**CITY OF PORTLAND**

Permit Number: 070913

This is to certify that PIXLEY ANDREW C /Jayson Cundowhas permission to 14' x 12' rooftop deckAT 705 CONGRESS ST

<b>Proposed Use:</b> 1 commercial restaurant on the 1st floor and 4 residential condos in the rest of the building - new 14' x 12' rooftop deck for condo #4	<b>Proposed Project Description:</b> 14' x 12' rooftop deck for condo #4
---	---

**FLOOR PLAN**

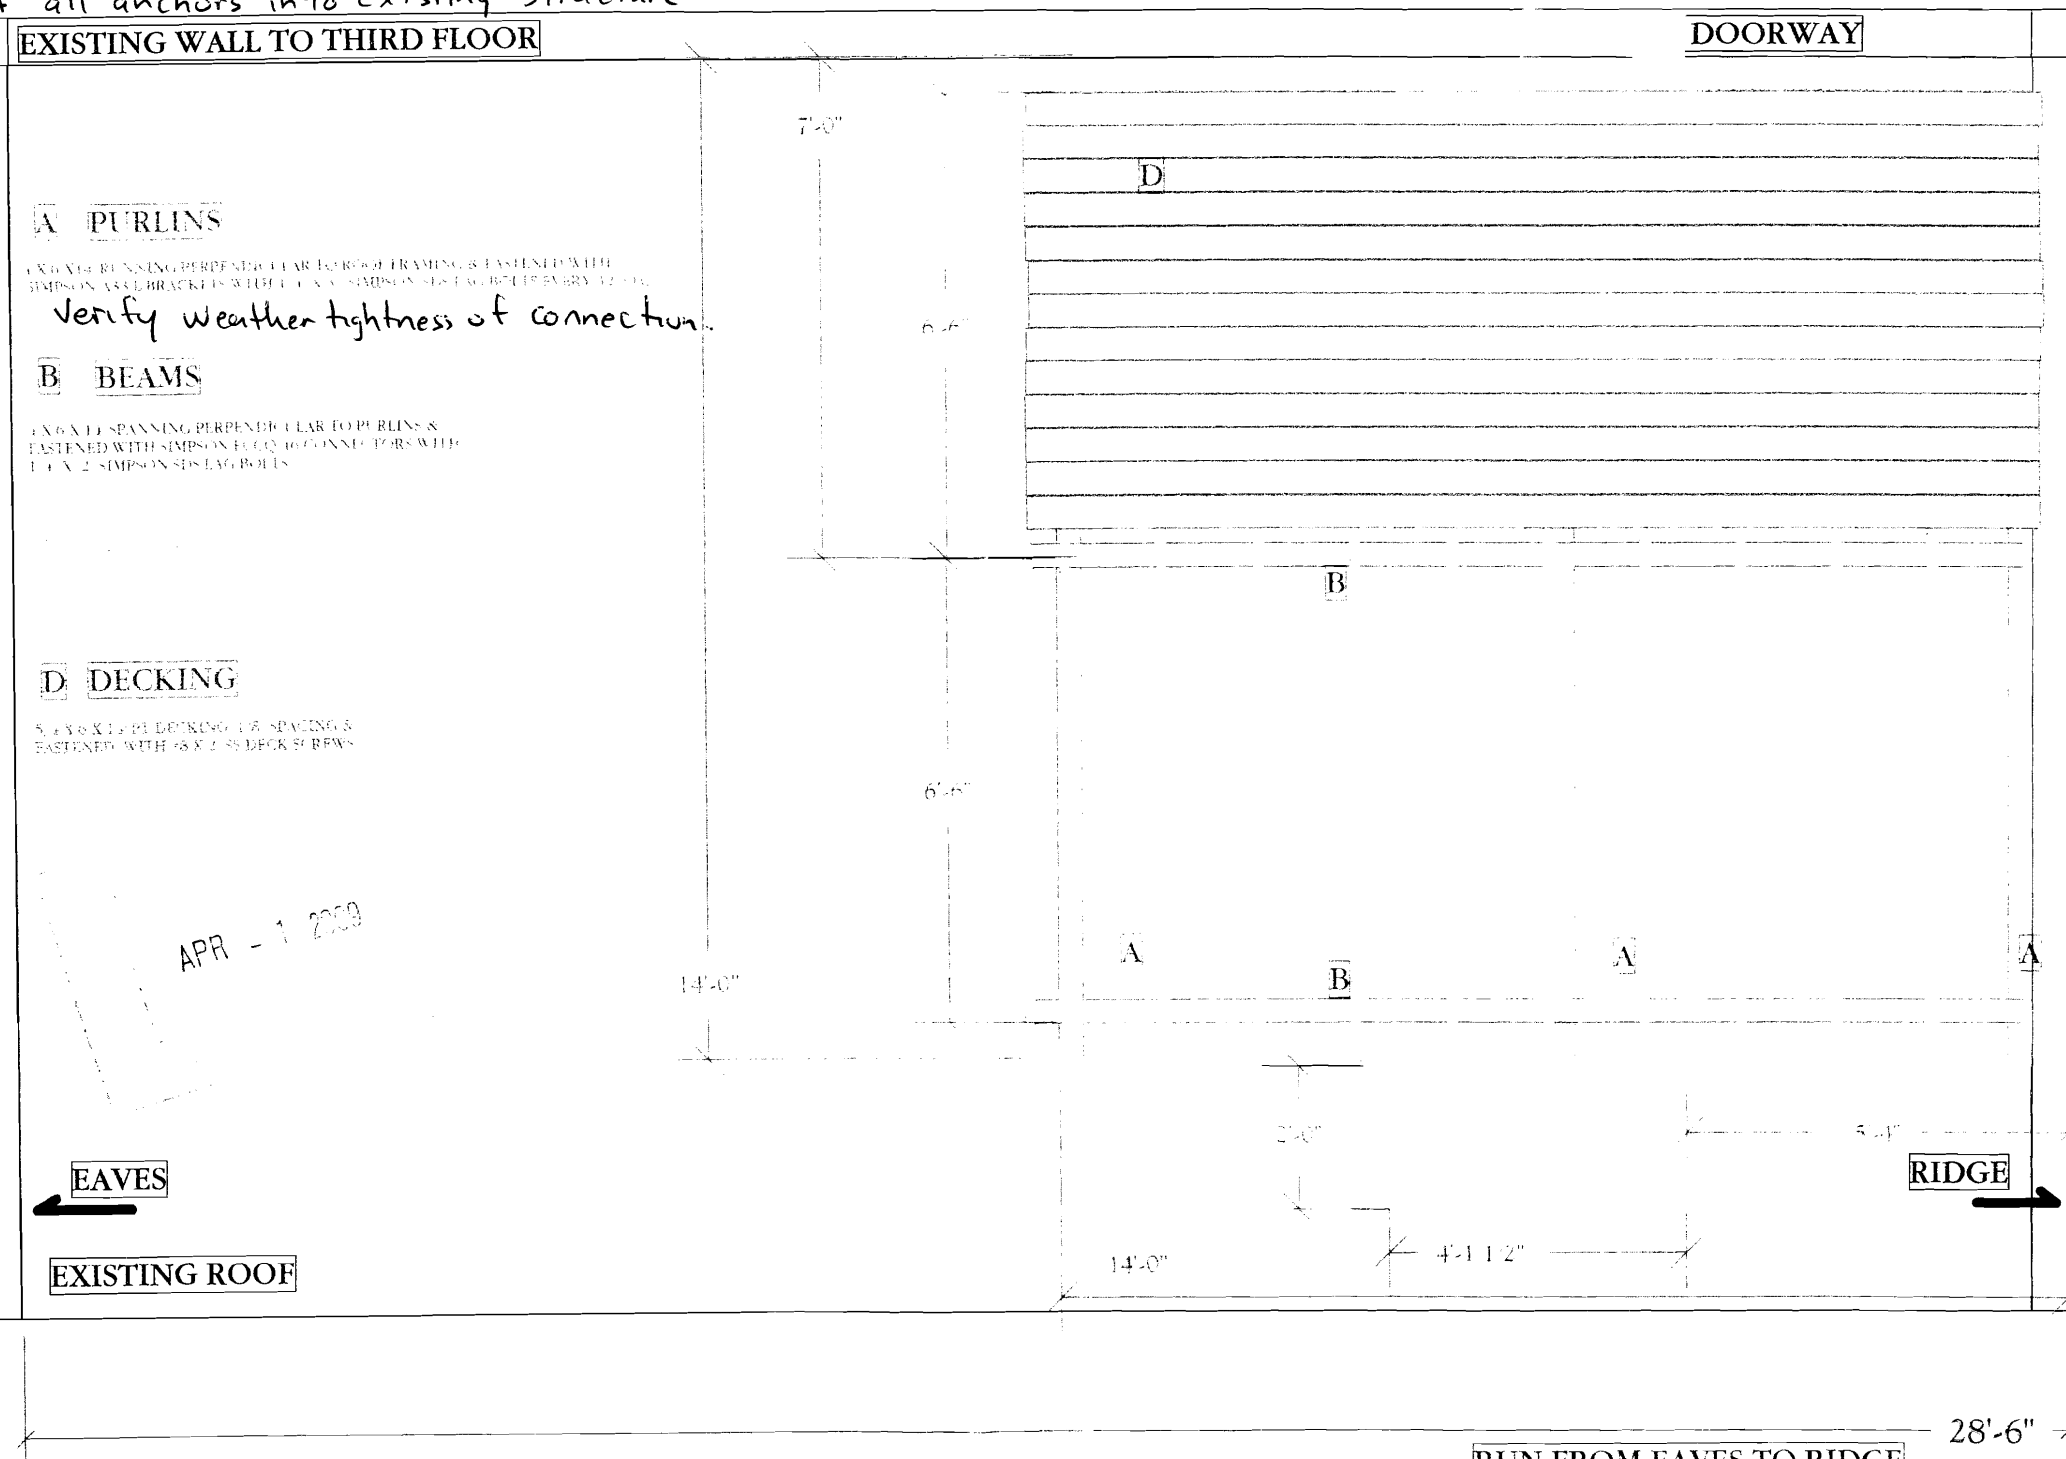
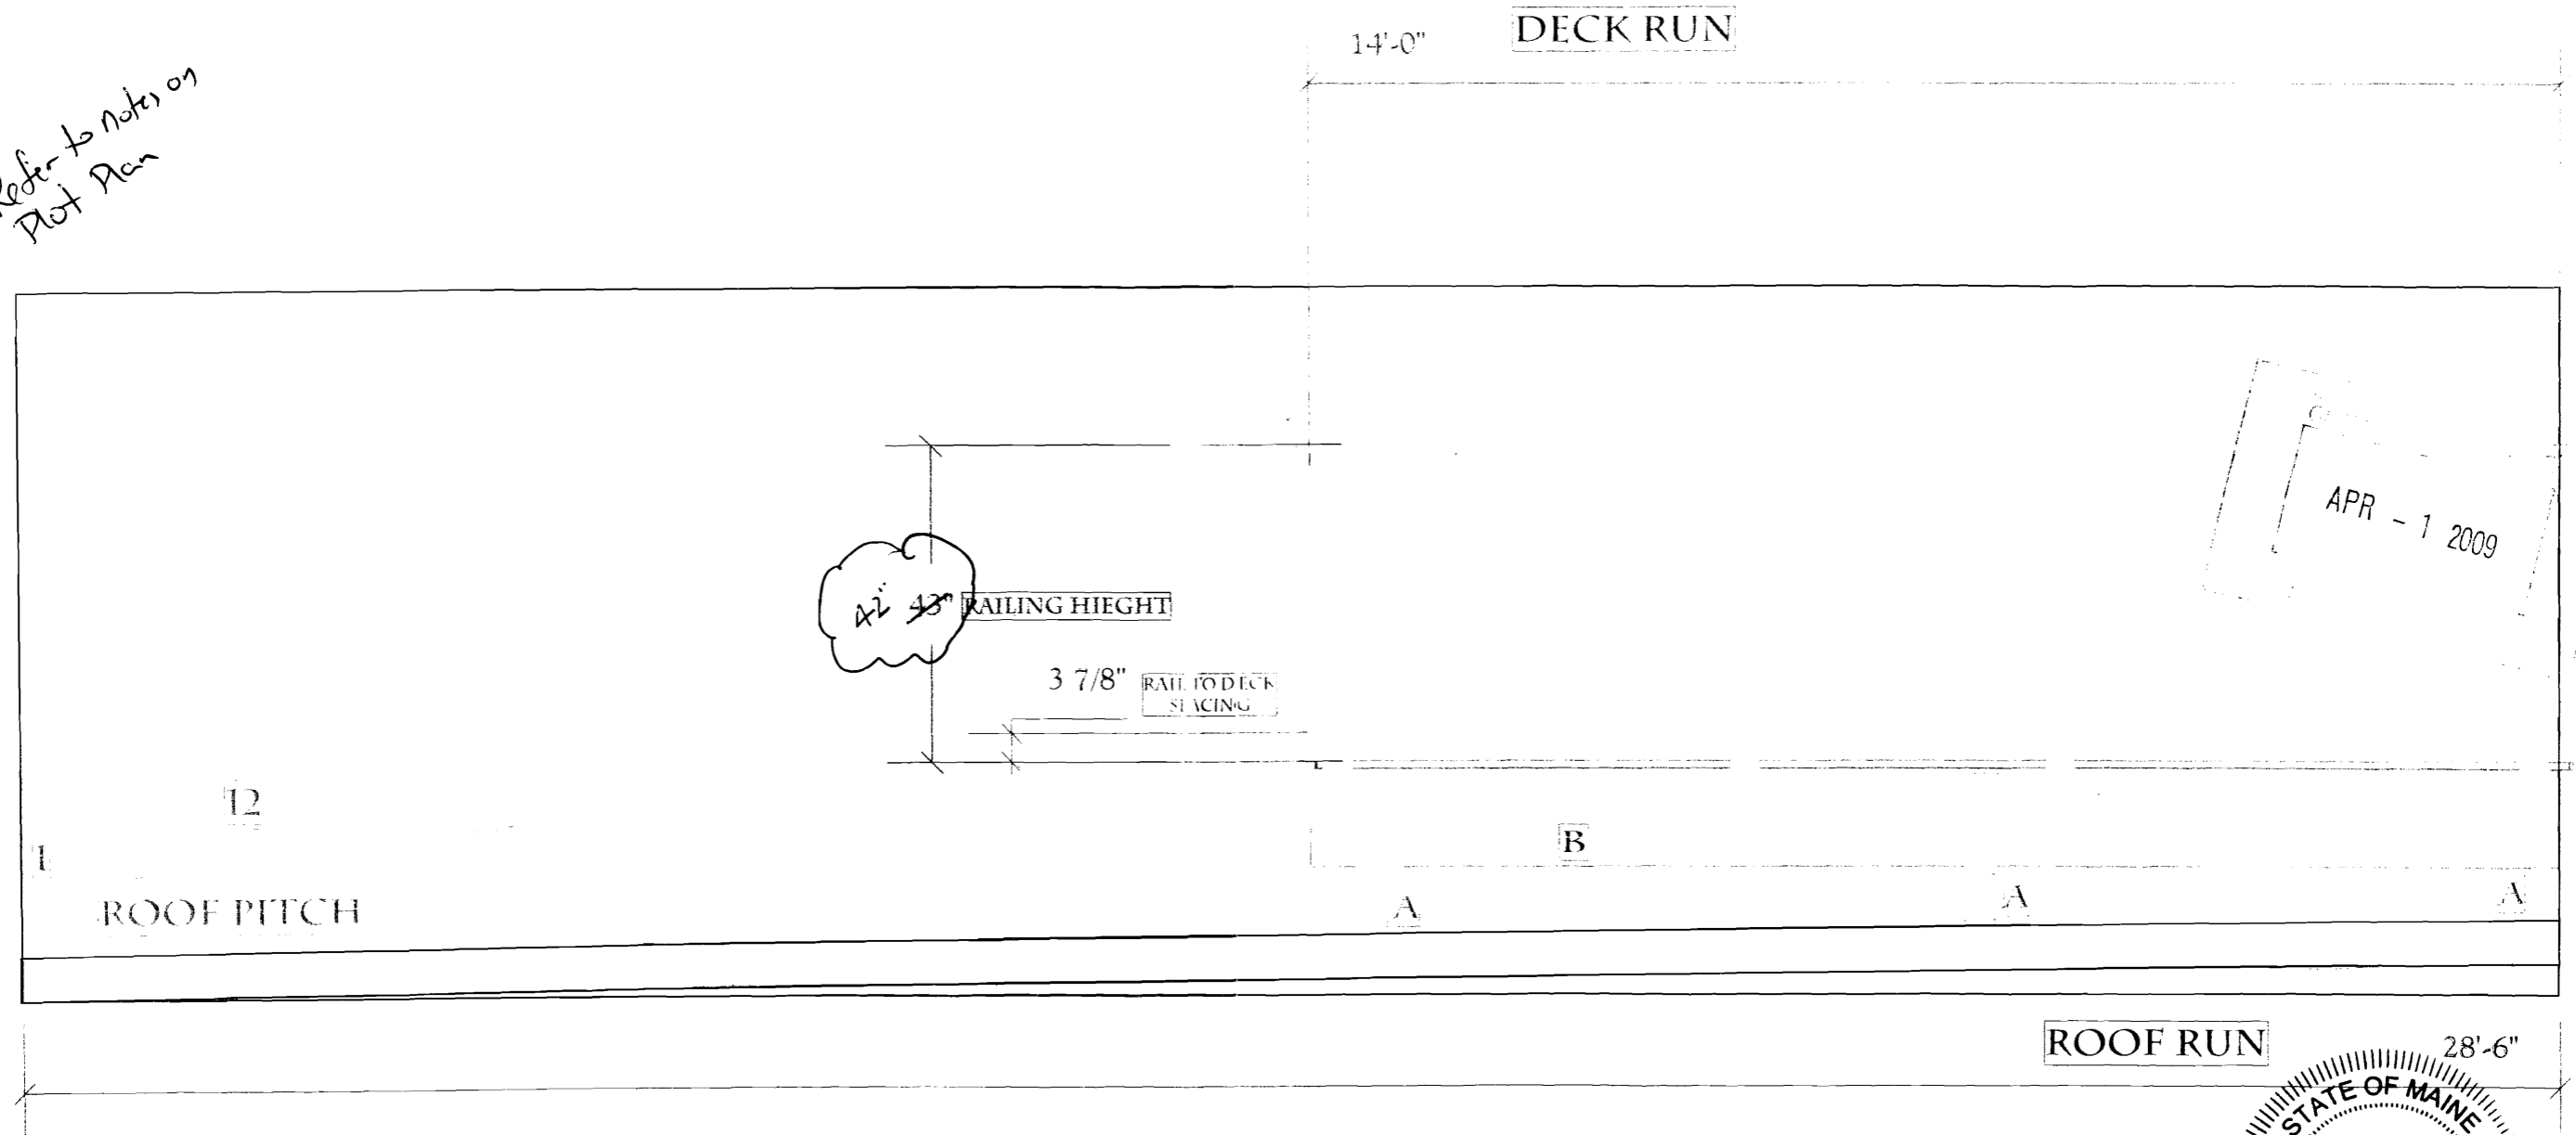
This Plan was reviewed for adequacy of existing Roof Framing to Support imposed loads by proposed Construction of wood Deck only. Contractor shall Verify installation of all anchors into existing structure and report to Engineer deteriorated or inadequate existing conditions.

Reviewed for Conformance to IBC 2006. Existing BLDG was not Reviewed as part of this Limited building Design.

Verify weather tightness of connection.

TITLE	DRAWN BY CCS	<b>PALERMINO DECK</b> 705 CONGRESS ST. UNIT 4 PROTLAND, MAINE
<b>NW ELEVATION</b>	DATE 3/14/09	
	SCALE: 1/2" = 1'

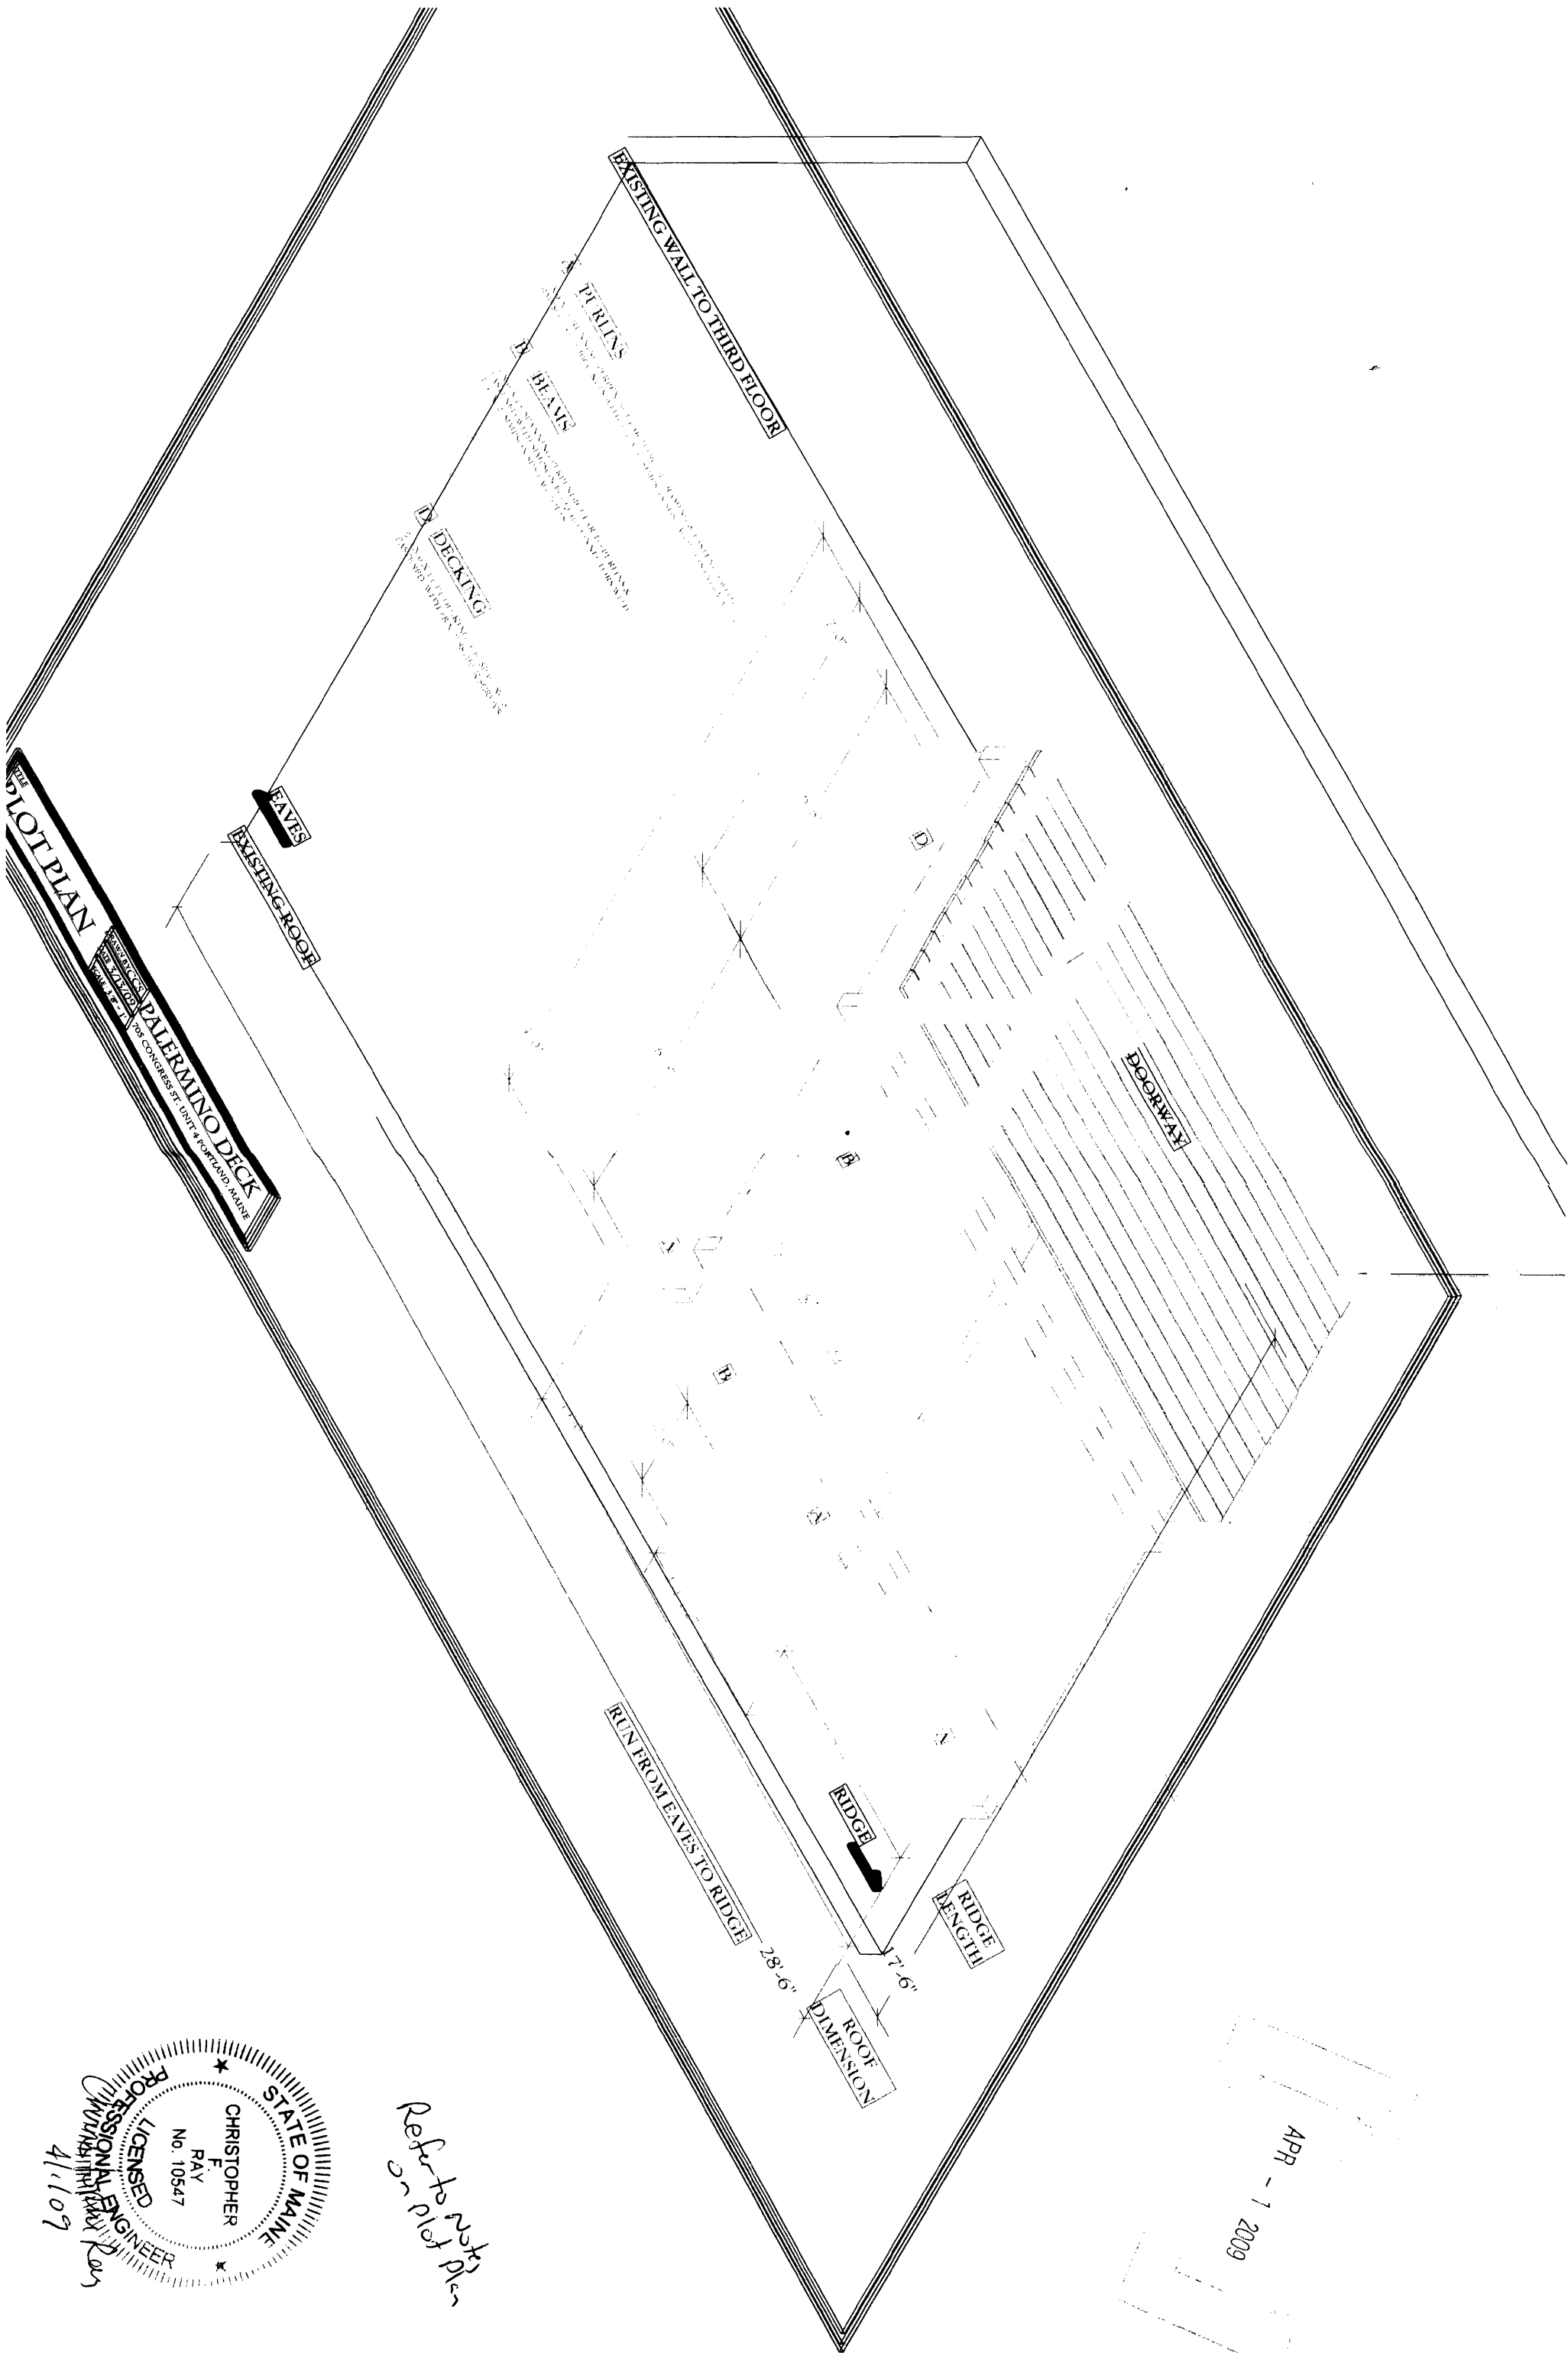
*Refer to notes on  
Plot Plan*
